Landscape & Visual Impact Assessment (LVIA) Addendum

Project: Land North of Arborfield Road, Shinfield, Berkshire

March 2025

TITLE
Land North of Arborfield Road, Shinfield
Landscape Strategy Plan

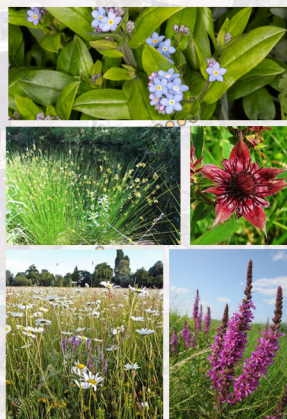
5	<i>It is helpful that the LVIA has undertaken an assessment of the Landscape Value of the site and in relation to its localised setting (paragraphs 3.67–3.71 including Table 1). I agree with the findings of the assessment in the main but the site’s eastern boundary even though it immediately abuts the landscape edges of the A327 Eastern Relief Road still has a strong visual relationship to the Loddon River Valley landscape to the east which has been identified as a Valued Landscape in the WBC Assessment dated September 2024. This should be recognised in the design and treatment of this edge to development as well as the layout of the housing on site, and how it relates to the wider landscape (this will be</i>	It is acknowledged that the landscape to the east forms part of the wider River Loddon Valued Landscape as per WBC’s Valued Landscape Assessment dated September 2024. It is noted that this document does not appear to differ greatly in relation to the information previously provided on the River Loddon Valued Landscape identified within the Topic Paper – Valued Landscapes published in 2020, which is referenced within the submitted LVIA. It is agreed that the vegetation structure in the eastern extents of the Site forms a visual link to the existing vegetation structure within the area of valued landscape to the east. The layout and landscape proposals have since been updated to further enhance this visual connection as illustrated on the revised ASP6 – Landscape Strategy Plan appended to this document, with the aim of bringing

<i>discussed in further detail in the layout and landscaping section below).</i>	the landscape further into the Site to establish a high-quality transitional settlement edge.
6	<i>“Chapter 4 of the LVIA provides a description of the proposals and landscape strategy. It is important to understand how the design of the proposed development relates to the landscape guidelines for the two LCA’s, with design of the development picking up those guidelines in J3 and the eastern edge strongly relating to the guidelines in A2 to provide a positive landscaped boundary with the open countryside reflecting the rural character of the adjacent river valley.”</i>	Please refer to Section 3 of this LVIA Addendum as to how the Proposed Development relates to the landscape guidelines for LCA A2 and LCA J3 of the Wokingham Borough Landscape Character Assessment (WBLCA; 2019).
7	<i>“Key elements of the landscape strategy are listed in paragraph 4.7 with an emphasis on green infrastructure incorporated through the site. In considering the layout (detailed comments are provided on this later) there are a number of issues relating to the layout of the site which need to be resolved as I don’t consider there is sufficient or appropriate space provided within the development to provide a network of green infrastructure, and this then has implications as to how the development is mitigated and integrated to provide that integration with the countryside beyond the site (see above point).”</i>	The key elements of the landscape strategy as listed in paragraph 4.7 of the submitted LVIA remain applicable. The layout has since been amended to bring the landscape further into the development area by creating a larger area of public open space at the heart of the development along with increased space within the street scene to accommodate further street tree planting to enhance the green infrastructure provision running through the development. The proposed road and housing configuration along the eastern extents of the developable area have also been revised in order to create a better transition with the landscape buffer to the east and to establish a better visual link between the development and countryside beyond.

12	<i>“Although I agree in part with the conclusion that the site is influenced by the adjacent settlement boundary, I would add that this is also true with regards to the sensitive eastern edge of</i>	It is agreed that the open countryside beyond the A327 Eastern Relief Road has an influence on the eastern extents of the Site. The landscape proposals are designed to strengthen this connection with the

<i>the site where adjacent to the open countryside and valued landscape which is also influenced by the river valley landscape. I am not clear as to how the guidelines within the WBLCA have informed the design of the site or the landscape proposals. I agree that views of the development will be mostly limited to the localised setting, but consider more can be done to integrate the development into the wider landscape which could have been done as part of the LVIA in order to inform the layout within the site to reduce adverse effects."</i>	countryside beyond by establishing a high-quality, transitional edge to the development. Please refer to Section 3 of this LVIA Addendum for additional information as to how the guidelines for the relevant LCAs of the WBLCA have informed the layout. The revised proposals are illustrated on ASP6 – Landscape Strategy Plan appended to this document.
--	--

<i>development into the wider landscape.”</i>	countryside beyond through increased green space, plot frontages and street tree planting along the shared access roads in the eastern portion of the development area. The landscape buffer to the east has been re-worked to provide further native shrub and tree blocks to complement the establishing planting. This planting will be informal in character to reinforce the rural edge to the development, while retaining a degree of permeability between the settlement and rural landscape beyond the A327 Eastern Relief Road.
10	<i>“With regard to the assessment of visual effects I consider the assessment of several viewpoints need further comment. With regard to Viewpoint 5 from Arborfield Road the view is specifically taken from Vickers Close, however longer views along Arborfield Road should also be considered as there will be an almost total loss of the hedgerow (H3 & G11) to the south of the site in order to accommodate the highway requirements and increase in road width of Arborfield Road to include a right hand turn into the site. I don’t agree with the assessment in Table 7 that there will be a partial loss, as the Tree Protection Plan indicates a significant loss of vegetation along this boundary. The development proposals indicate there will be some mitigation planting along the boundary, but in combination with the new infrastructure (road and footway / cycleways) I consider the magnitude of change will be greater than as indicated especially as there will be more than a fleeting view of the proposed development. I consider the views will be open and direct leading to Moderate Adverse even at Year 10.”</i>	From Arborfield Road with the Vickers Road junction (Viewpoint 5), existing views of the off-site roadside vegetation structure in view along Arborfield Road will be mostly retained. However, it is acknowledged that there will be an almost total loss of vegetation along the southern Site boundary. It is also recognised that from the stretch of Arborfield Road that runs by the southern Site boundary, the loss of this established roadside vegetation to accommodate site access along with footpath enhancements on the northern side of Arborfield Road will likely result in a high magnitude of change at Year 1 on road users considered to be of low sensitivity. It is therefore agreed that from this stretch of road, a Moderate Adverse effect will be likely, which is not considered to be significant. Effects will likely reduce as the mitigation planting in the form of native hedgerow and hedgerow trees along with native trees in open space beyond this replacement hedgerow establish to filter views of the proposed built form, which will be set back from this road. It is noted that further hedgerow tree planting is now proposed as part of this mitigation planting to further soften views of the built form.
